REMARKS

Claims 1-2 and 6 were rejected under 35 U.S.C. §102(b) for allegedly being anticipated by Cho. It is respectfully submitted that the rejection does not apply to the presently pending claims.

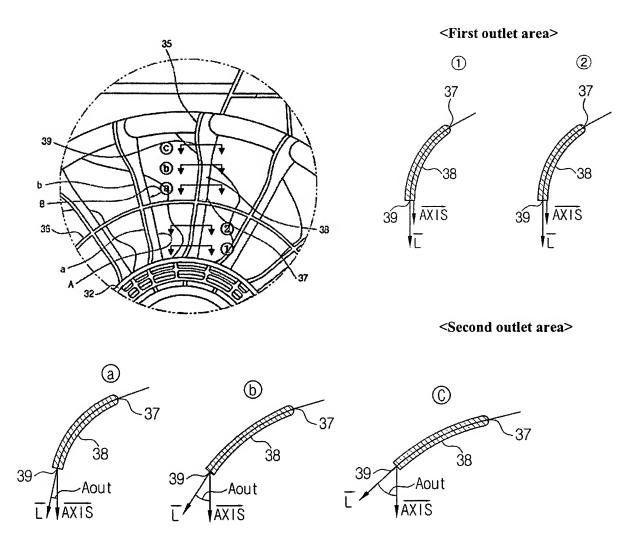
It is respectfully submitted that the angle of projection gradually increases from 0° to 30° since the Examiner measured an angle formed between the two straight lines as shown in the drawing below:

The Examiner points out that an r/R value ranges from 0.4 to 0.7 and an air flow guide surface is curved into the form of an arc from a leading edge to a trailing edge.

According to Tsubakida, the outlet area referred to by the Examiner means an area that a guide blade is curved at a predetermined angle to a part parallel with a line passing the center of the fan.

However, according to the presently claimed invention, the first outlet area is an area that the angle of projection is 0° but the second outlet area is an area that the angle of projection gradually increases.
